# **Lower Thames Crossing**

## **Thurrock Council Comments on Applicant's Submissions at Deadline 6 (D6)**

**17 November 2023**

Figure D.2.1: Spiral Marking and Lane Allocation Orsett Cock (also showing Order Limits in red outline)

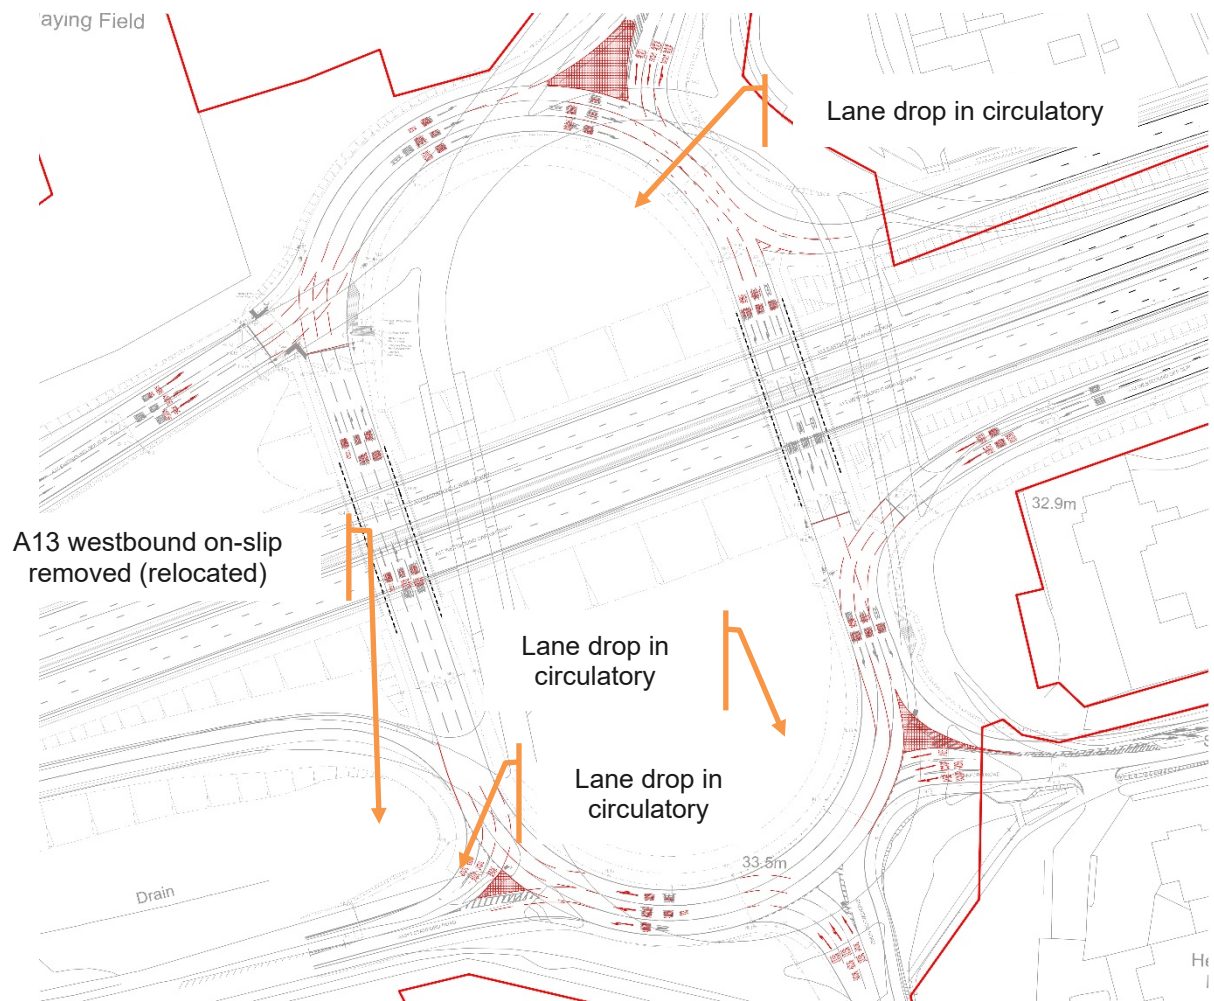
- D.2.7. A further change that has been included in the updated VISSIM model is a series of 'Lane Drops', included to the Orsett Cock circulatory to create a spiral layout.
- D.2.8. These amendments to the lane markings improve the traffic flow on the circulatory carriageway, particularly on the approach to conflict points. The spiral markings prevent traffic lane weaving as traffic seeks to move across lanes to depart from the circulatory. Lane drops have been added after the A128 Brentwood Road (North) approach; after the A13 East approach; and, at the A1013 West approach.
- D.2.9. In addition, the lane allocation on the approaches to the Orsett Cock Junction has been revised to provide a better distribution of traffic flow across the available lanes. **Figure D.2.1** below shows the lane marking changes that have been modelled.

Figure D.2.2: Signalised junction for Stanford Road / A13 westbound on-slip

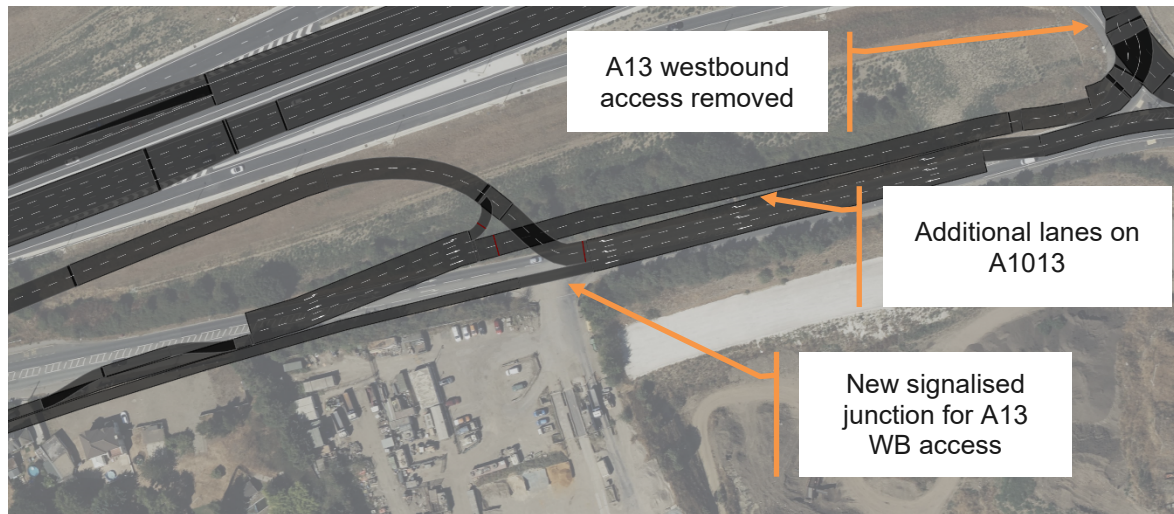
D.2.11. To reduce delays on this arm, the A13 WB on-slip has been removed from the Orsett Cock Junction in the VISSIM model and relocated so that the A13 westbound on-slip is provided from the A1013 Stanford Road (West) as shown in Figure D.3 below.

**Figure D.3.1: Comparison of LTAM with VISSIM v3.6T. 2030 PM Peak Hour (1700-1800). Delay per Vehicle (seconds)**

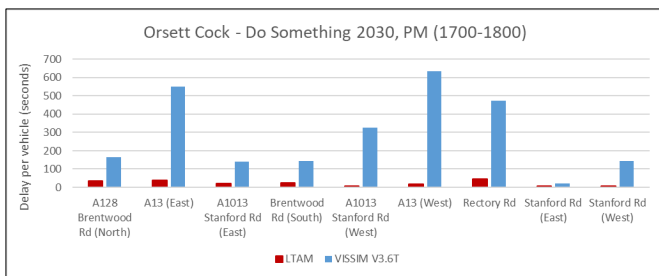
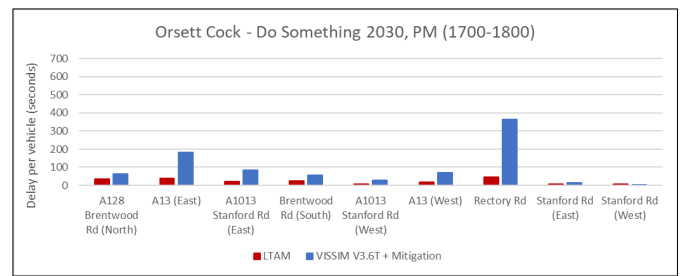
D.3.6 **Figure D.3.1** and **Figure D.3.2** below show this data graphically and clearly show the lack of alignment between the delays forecast by LTAM and VISSIM v3.6T, but a significant improvement towards the convergence between the two models with the additional mitigation tested in VISSIM v3.6T + Mitigation.

**The Draft Requirement will mean that more design and analysis work is required with constraints of Order Limits, limits of deviation and Rochdale Envelope**

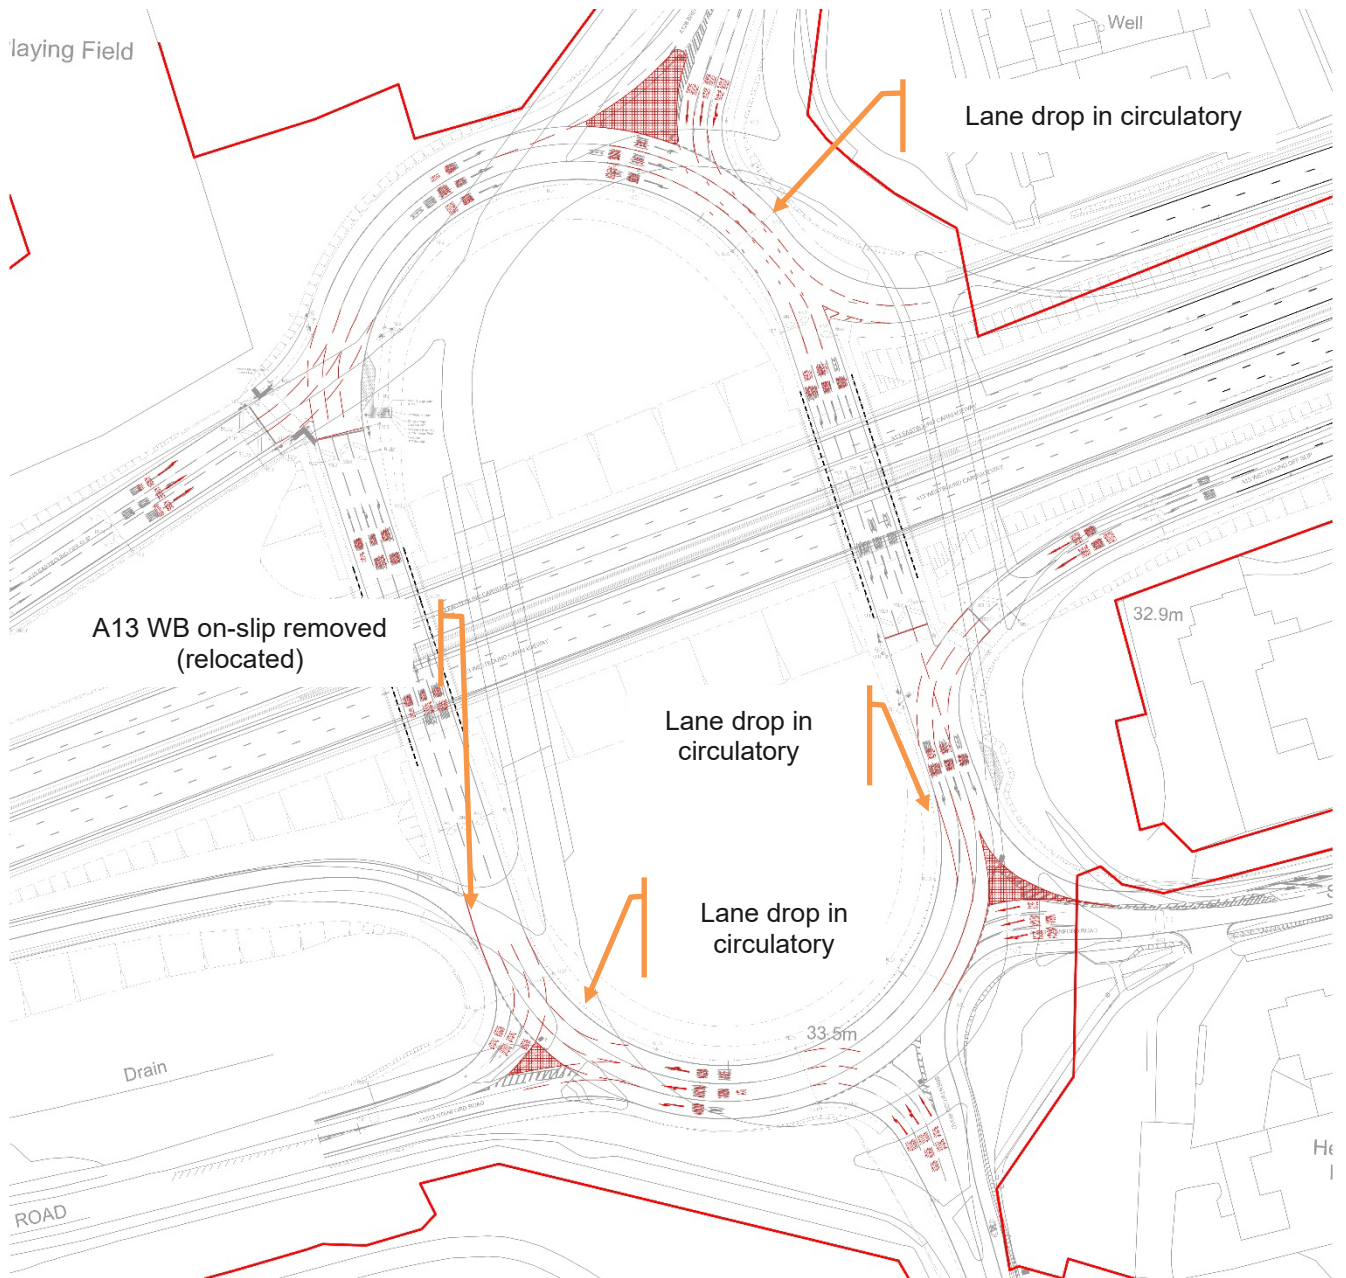
- D.4.8. The Council as Local Highway Authority with responsibility for Orsett Cock Junction insists strongly that for the DCO to address the traffic impacts of LTC at Orsett Cock in an acceptable way, the draft Requirement for Orsett Cock Junction jointly put forward by the Council, PoTLL, DPWLG and TEP at D6 ([REP6-163](#)) and a Joint Position Statement at D6A ([REP6A-017](#)) and ([REP6A-013](#)) must be secured within the dDCO.

- D.4.9. Without this draft Requirement, the traffic impacts at Orsett Cock are unacceptable to the Council.

- D.4.10. The draft Requirement put forward by the Council, PoTLL, DPWLG and TEP would require an intense period of further assessment, mitigation testing and design to be undertaken by the applicant. The Council and other stakeholders would need to be consulted throughout the period prior and the scheme agreed, before the submission of the final design and assessment to the SoS for approval.
